SAN FRANCISCO UNIFIED SCHOOL DISTRICT
2011 PROPOSITION A BOND PROGRAM
Miraloma ES & Sunnyside ES Green Schoolyard

ADDENDUM NO. 1

PROJECT: **Miraloma Elementary School**
175 Omar Way, SF, CA 94127

Sunnyside Elementary School
250 Foerster Street, SF, CA 94112

AD1-SK1

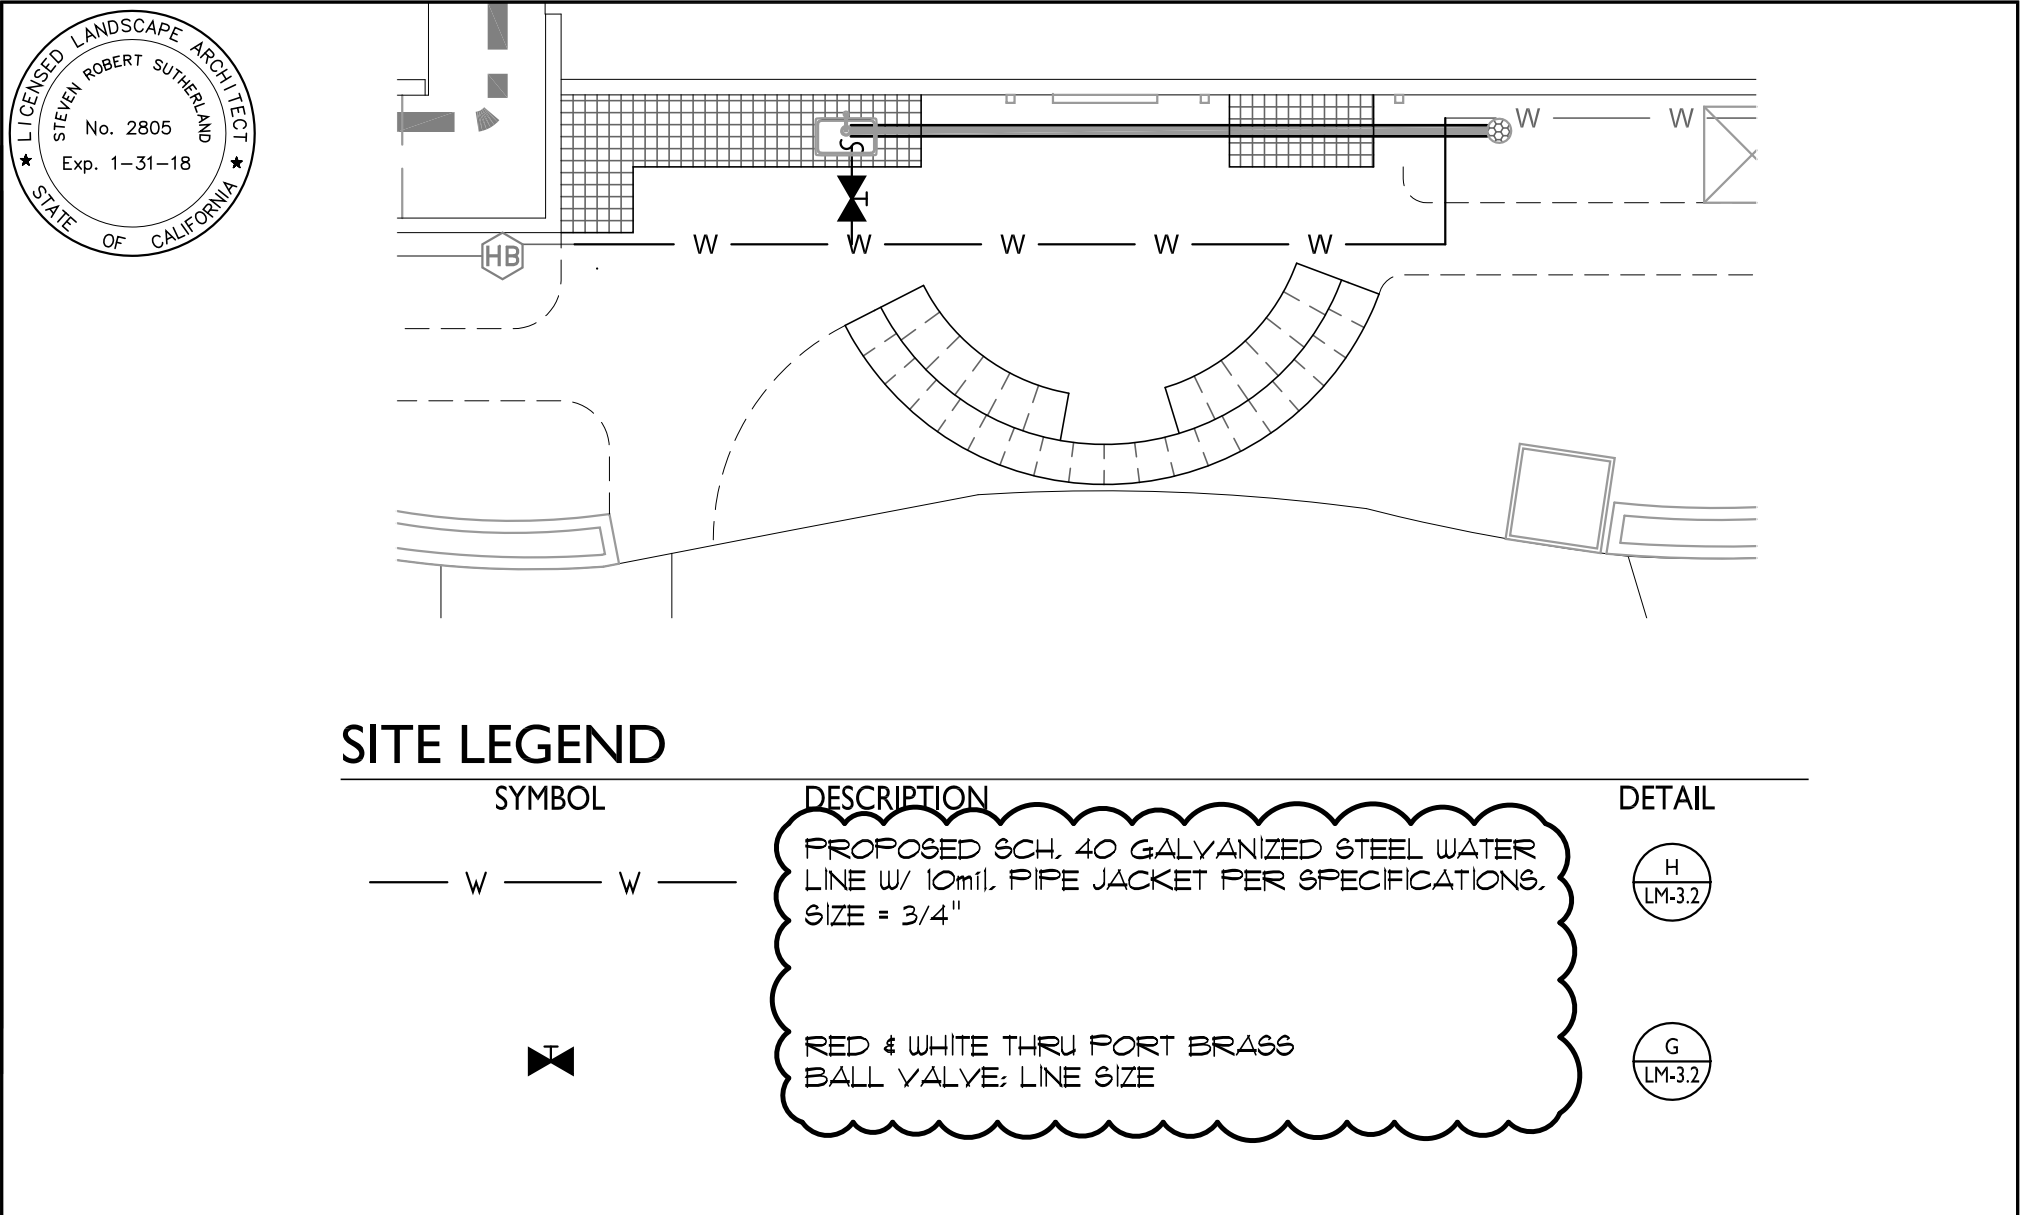
4. **Item No. AD1-4**
Reference: **DRAWING LM-2.0, SITE LEGEND**
Description: Revise the water line and shut off valve descriptions per AD1-SK1.
5. **Item No. AD1-5**
Reference: **DRAWING LM-3.0, DETAIL C**
Description: Revise the water line and shut off valve information per AD1-SK2.

DRAWING TITLE: WATERLINE CLARIFICATION
 REFERENCE DRAWING: LM-2.0
 ISSUED VIA: ADDENDUM NO. 01
 SCALE: 1/8" = 1' - 0"

DRAWING TITLE: SHUT OFF VALVE DETAIL CLARIFICATION
 REFERENCE DRAWING: LM-3.2, DETAIL G
 ISSUED VIA: ADDENDUM NO. 01
 SCALE: AS SHOWN

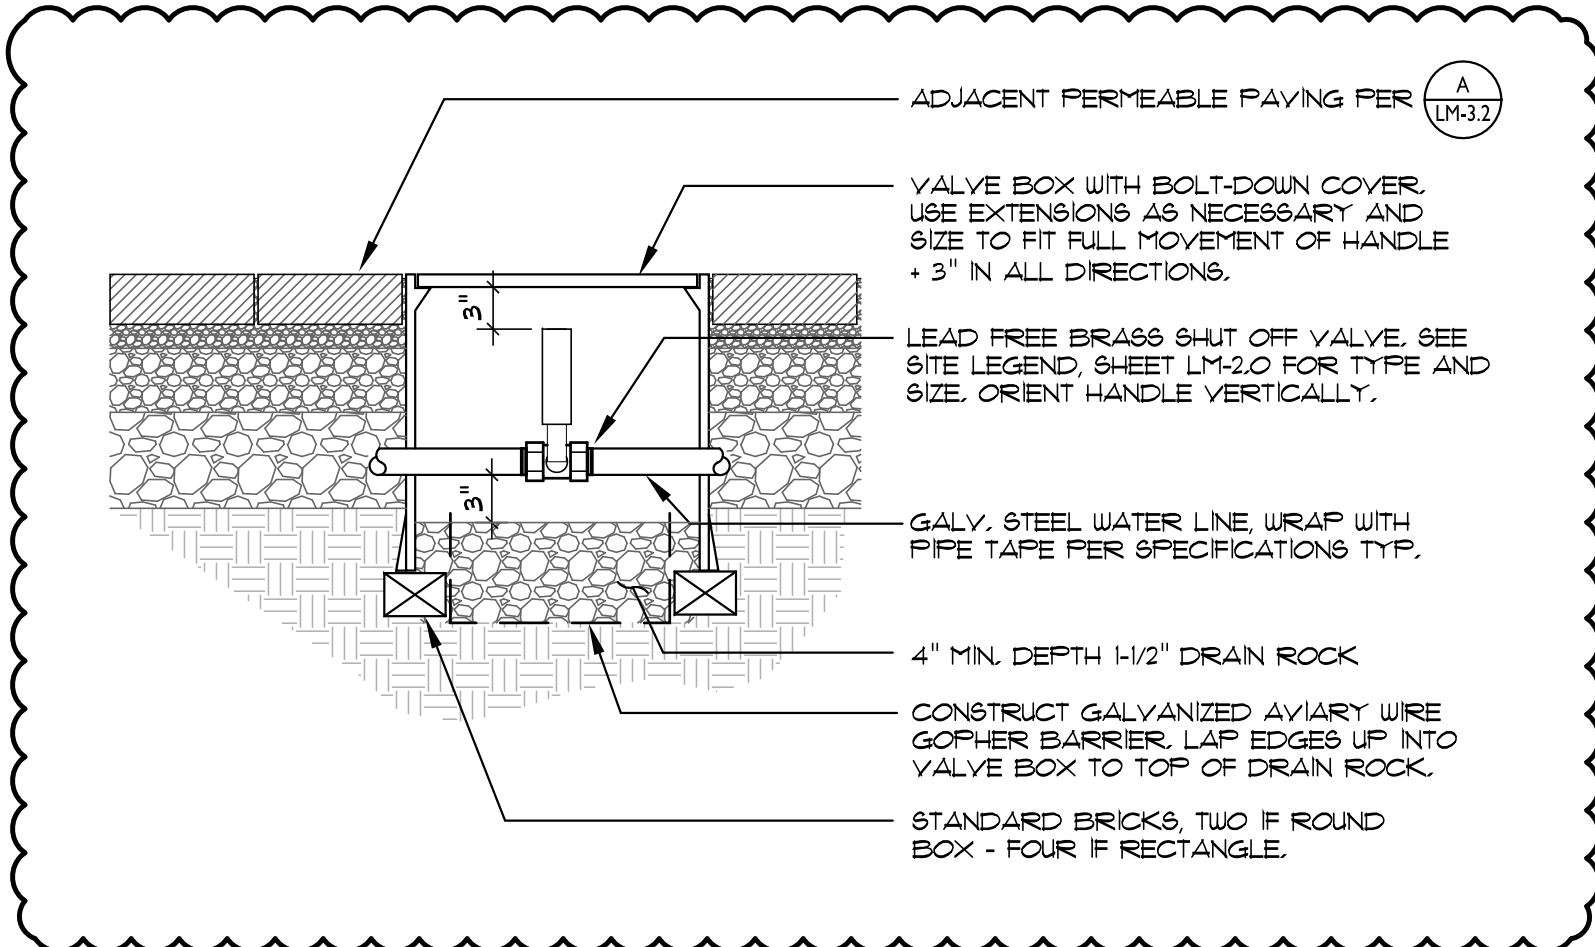
6. **Item No. AD1-6**
Reference: **Drawing LM-3.2 Construction Details**
Description: Delete details (D) and (E)
7. **Item No. AD1-7**
Reference: **DRAWING LM-3.2, DETAIL G**
Description: Revise the shut off valve detail information per AD1-SK3.

VALVE BOX WITH BOLT-DOWN COVER, USE EXTENSIONS AS NECESSARY AND SIZE TO FIT FULL MOVEMENT OF HANDLE + 3" IN ALL DIRECTIONS.

LEAD FREE BRASS SHUT OFF VALVE, SEE SITE LEGEND, SHEET LM-2.0 FOR TYPE AND SIZE. ORIENT HANDLE VERTICALLY.

GALV. STEEL WATER LINE, WRAP WITH PIPE TAPE PER SPECIFICATIONS TYP.

4" MIN. DEPTH 1-1/2" DRAIN ROCK

CONSTRUCT GALVANIZED AVIARY WIRE GOPHER BARRIER. LAP EDGES UP INTO VALVE BOX TO TOP OF DRAIN ROCK.

STANDARD BRICKS, TWO IF ROUND BOX - FOUR IF RECTANGLE.

AD1-SK4

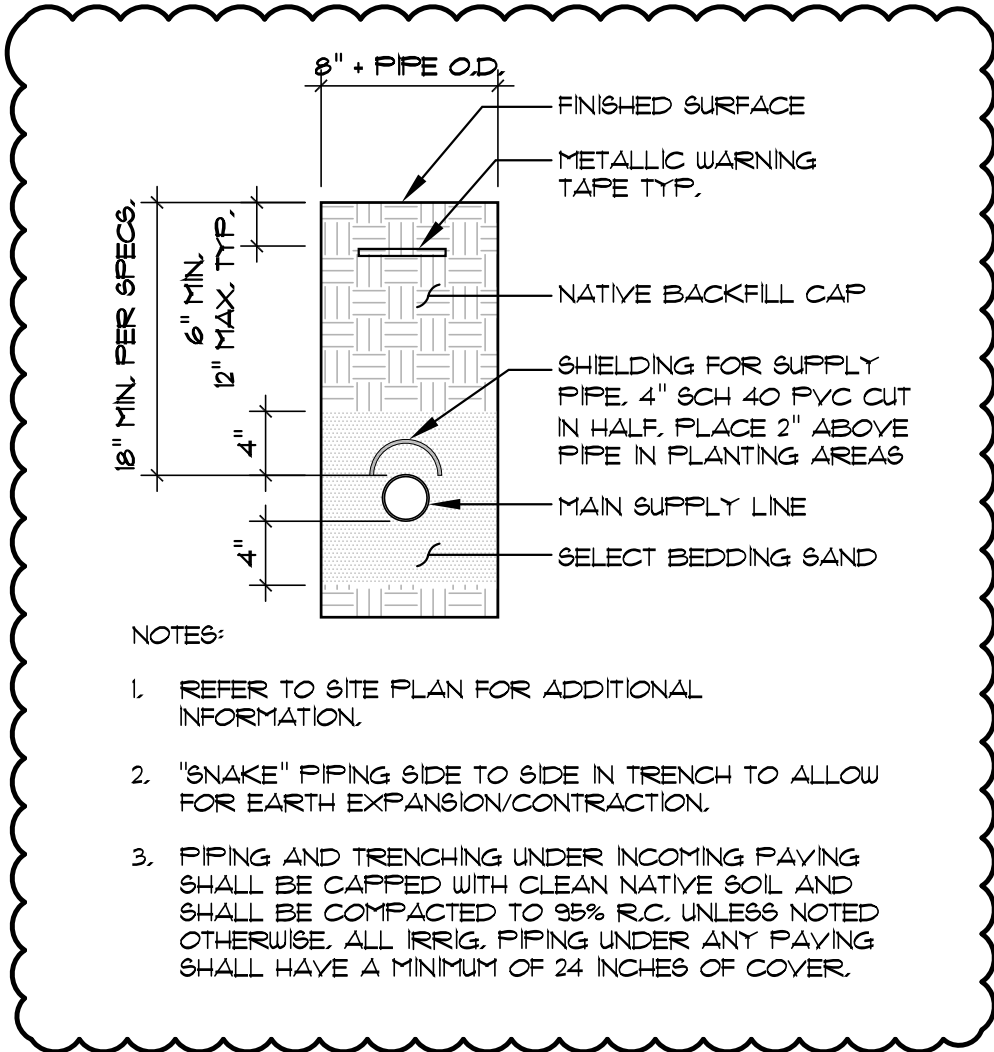
8. **Item No. AD1-8**
Reference: **DRAWING LM-3.2, DETAIL H**
Description: Revise the pipe bedding and protection information per AD1-SK4.
9. **Item No. AD1-9**
Reference: **DRAWING LS-4.0, DETAIL I**
Description: Revise the hose bid supply pipe information per AD1-SK5.

DRAWING TITLE: IRRIGATION PIPE BEDDING CLARIFICATION
 REFERENCE DRAWING: LM-3.2, DETAIL H
 ISSUED VIA: ADDENDUM NO. 01
 SCALE: AS SHOWN

AD1-SK6

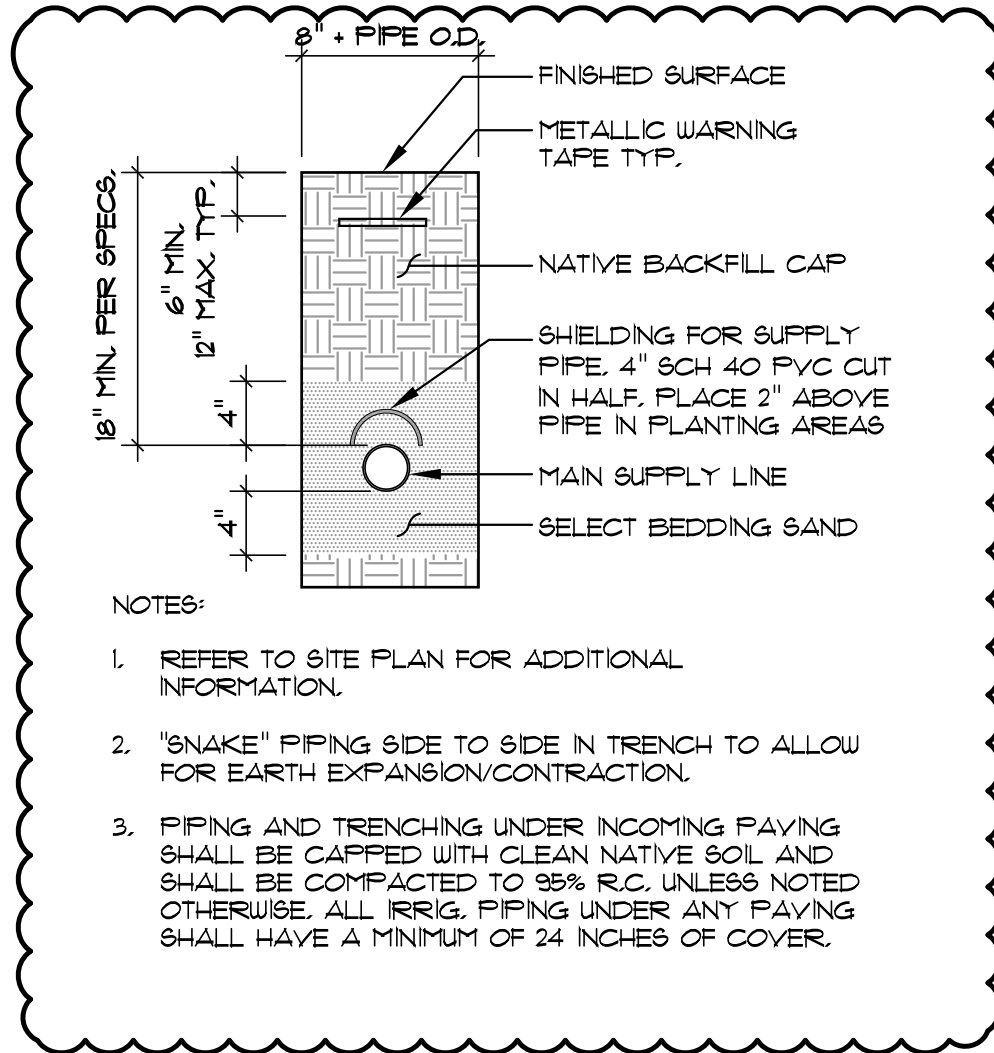
10. **Item No. AD1-10**
Reference: **DRAWING LS-4.2, DETAIL C**
Description: Revise the pipe bedding and protection information per AD1-SK6

1. REFER TO SITE PLAN FOR ADDITIONAL INFORMATION.
2. "SNAKE" PIPING SIDE TO SIDE IN TRENCH TO ALLOW FOR EARTH EXPANSION/CONTRACTION.
3. PIPING AND TRENCHING UNDER INCOMING PAVING SHALL BE CAPPED WITH CLEAN NATIVE SOIL AND SHALL BE COMPACTED TO 95% R.C. UNLESS NOTED OTHERWISE. ALL IRRIG. PIPING UNDER ANY PAVING SHALL HAVE A MINIMUM OF 24 INCHES OF COVER.

DRAWING TITLE: SHUT OFF VALVE DETAIL CLARIFICATION
 REFERENCE DRAWING: LS-4.2, DETAIL C
 ISSUED VIA: ADDENDUM NO. 01
 SCALE: AS SHOWN
